STAR ONLINE PUBLICATION

Case Number: S2108000002 Rev. C

Symptom/Vehicle Issue: In Cold Temperatures The Customer May Complain Of An Intermittent No Crank, Cranks And Stalls, Stops Cranking Fails To Start

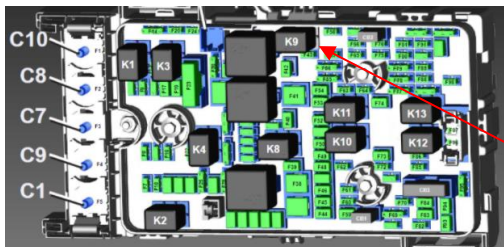
Repair Procedure: Inspect the Run/Start relay in the PDC and confirm it is manufactured by "Song Chuan" for vehicles built after September 2019. Replace the Song Chuan relay with the service replacement part (Denso 68406797AA). In the event 68406797AA is on backorder, another validated Denso relay to use is 68244159AA. Quantities for this relay are limited, we kindly request to only order on an as needed basis until mid March 2021 so customer vehicles currently exhibiting this issue can be repaired.

CAUTION: Denso relay part number 68244159AA can only be used in the Run/Start relay location. Premature relay failure will occur if used in other locations. Other locations require relays which can handle higher duty cycle requirements.

Note: Only the Run/Start relay will require replacement for this issue. No other Song Chuan relays should be replaced for this condition.
